Re: Response to Comments for Notice of Intent/Stormwater Report

Former Polymerine
241 Duchaine Boulevard, New Bedford, MA
DEP File # SE049-0730

RE: Nitsch Project #9972
Polymerine Site
New Plainville Road
New Bedford, MA

WETLAND RESTORATION PLAN

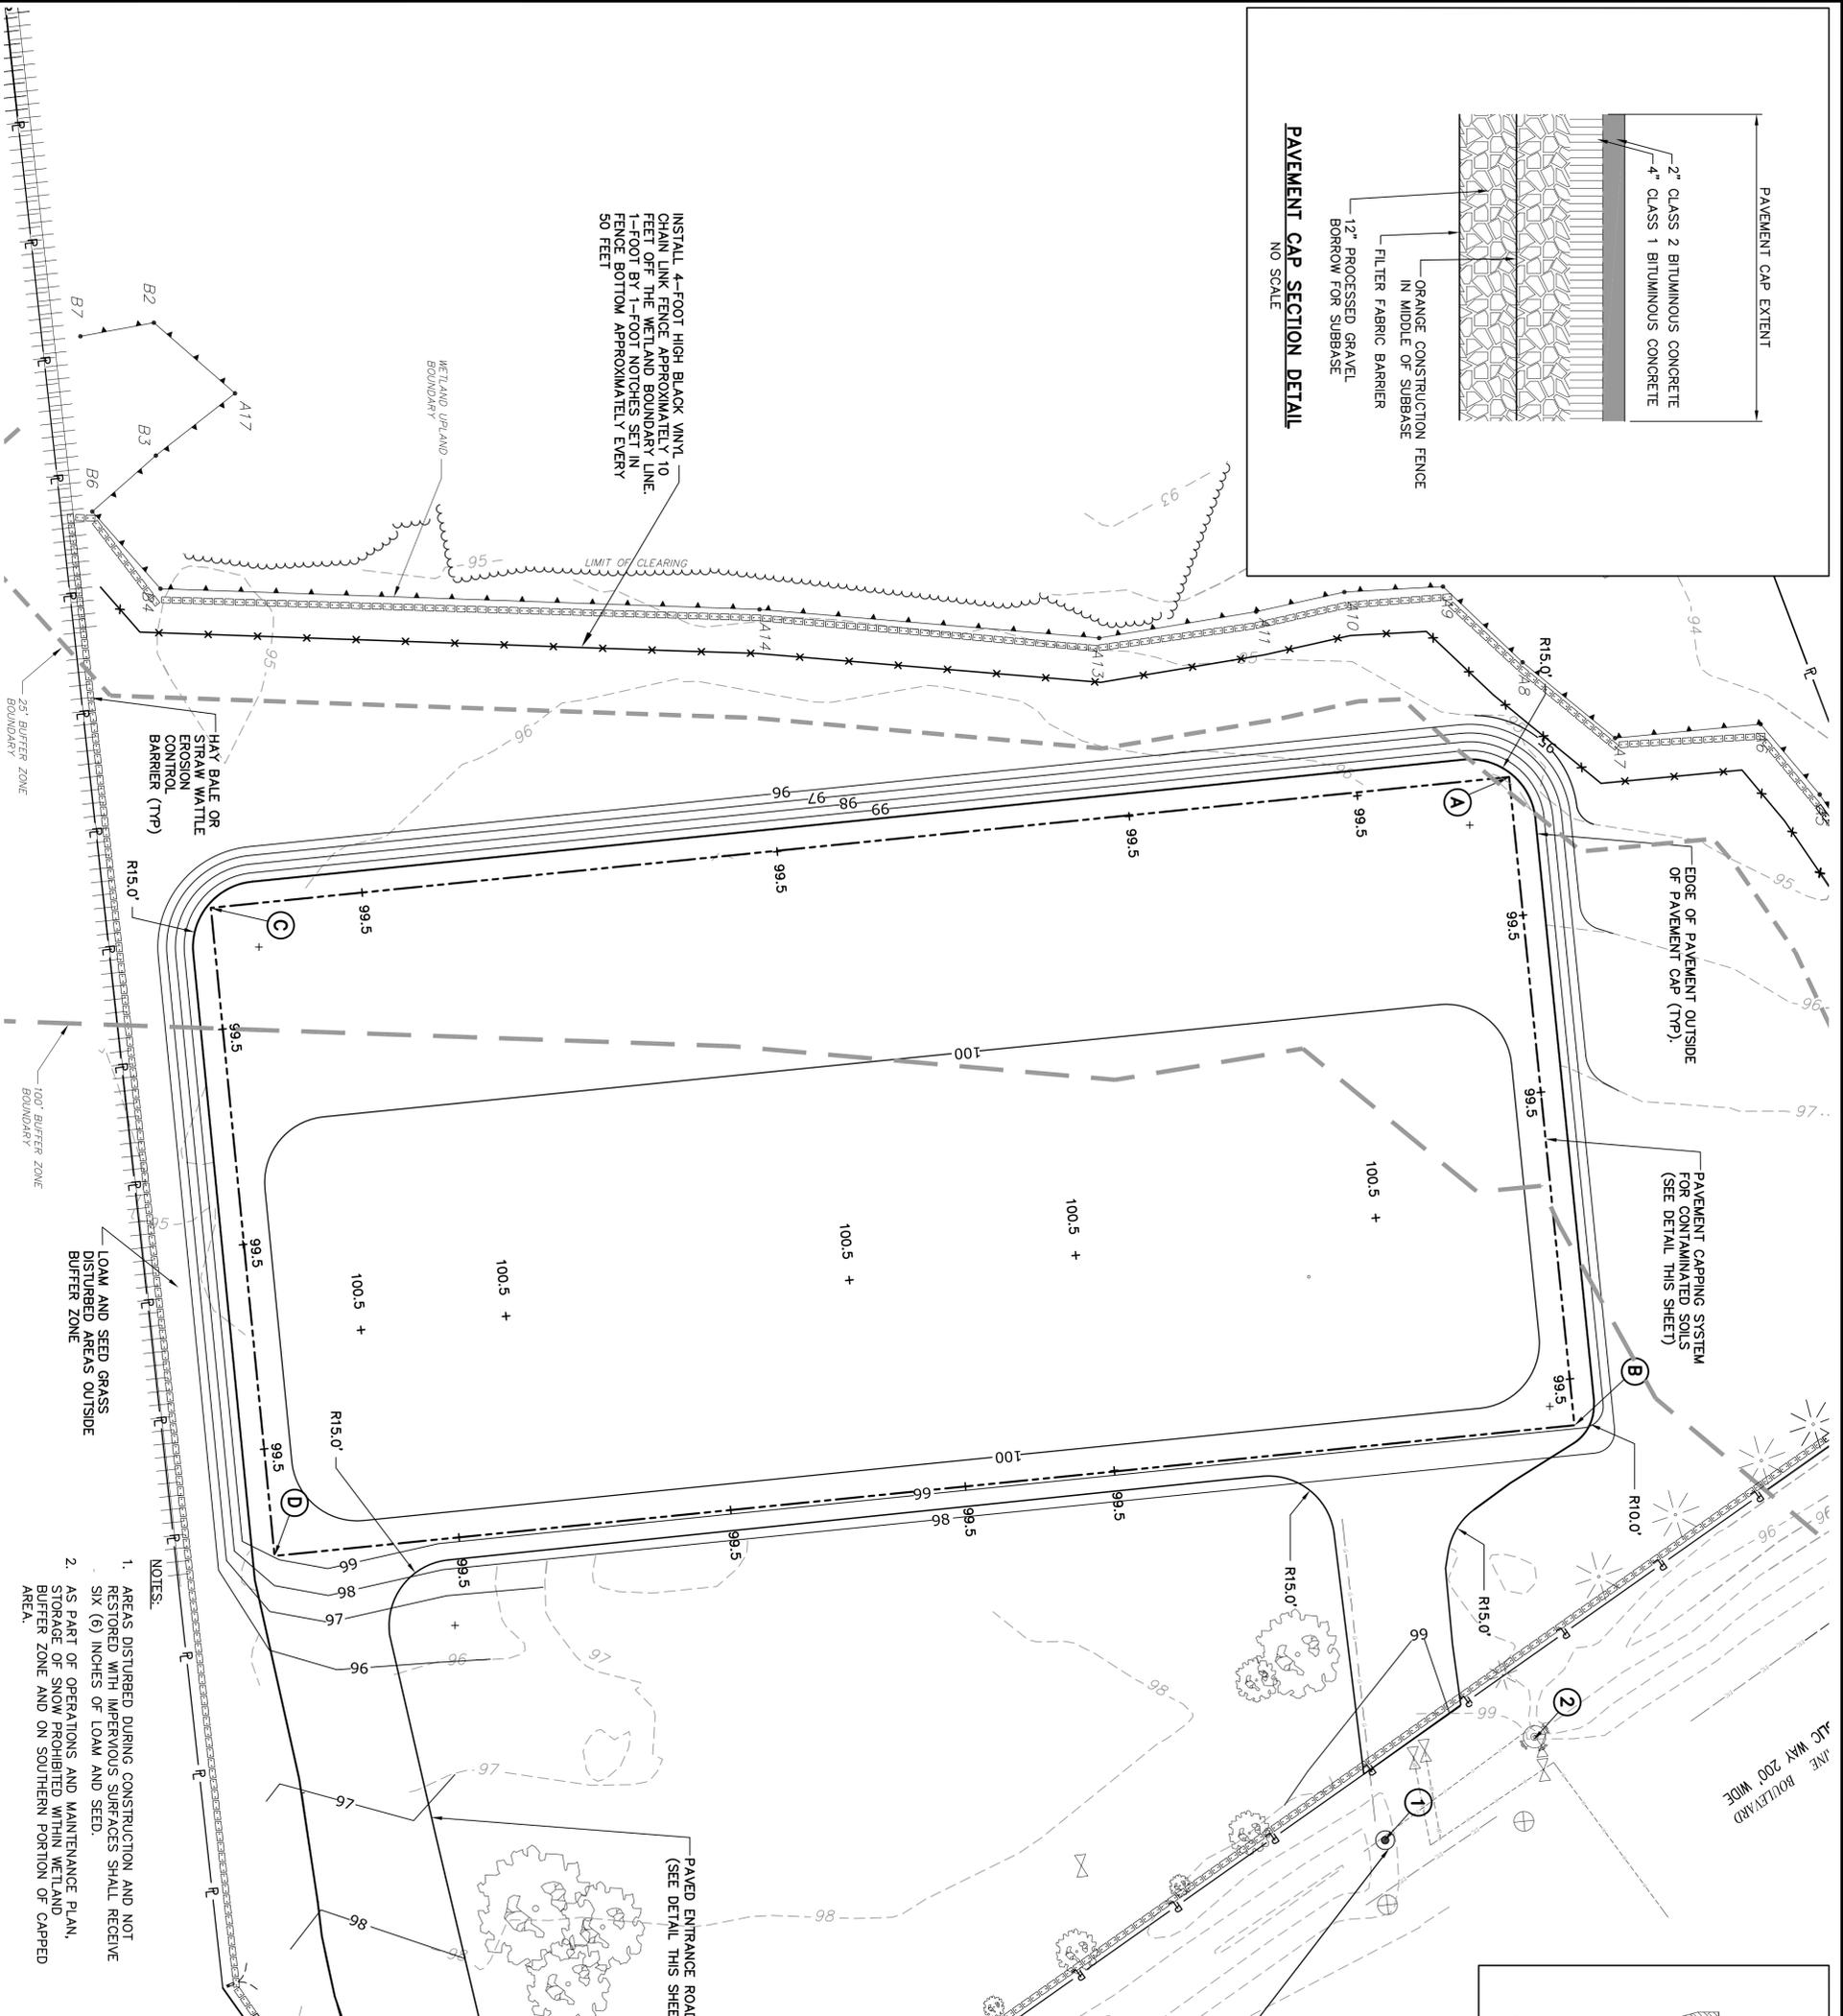
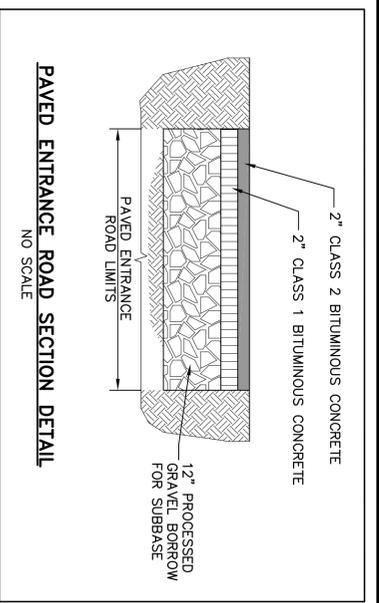
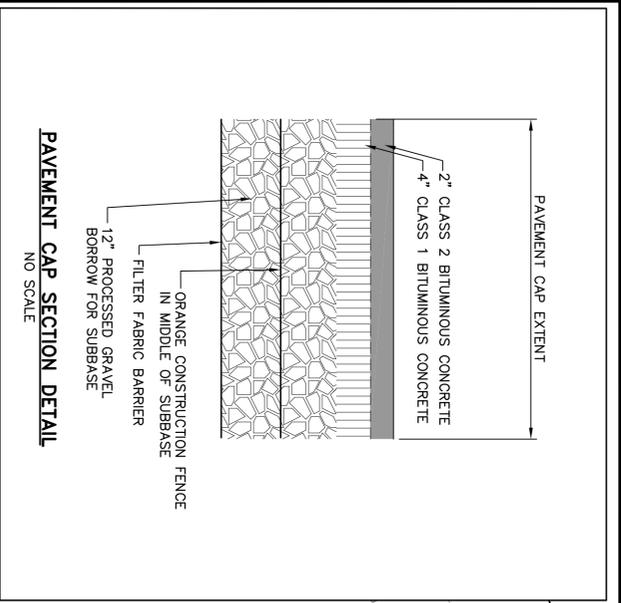
4. The project includes excavation within the wetlands. The plans do not quantify the amount of disturbance. However, the Notice of Intent (NOI) describes 1,880 square feet of wetlands disturbance. There is no remediation or restoration plan. The NOI simply describes restoring the disturbed wetlands with wetlands restoration mix. The Commission should consider requiring the applicant to provide a wetlands planting plan.

- **Comment No. 3:** The erosion control boundary to be installed has been revised on plan sheets 4, 5, and 6, with it now extending along the eastern portion of the site.
- **Comment No. 4:** The new plan sheet (5A) further depicts the wetland area to be temporarily impacted by the proposed excavation work. As stated in the NOI, this area is approximately 1,880 square feet. Plan sheet 5A also includes further details on the wetland restoration plan, including depth of excavation and replanting specifications.
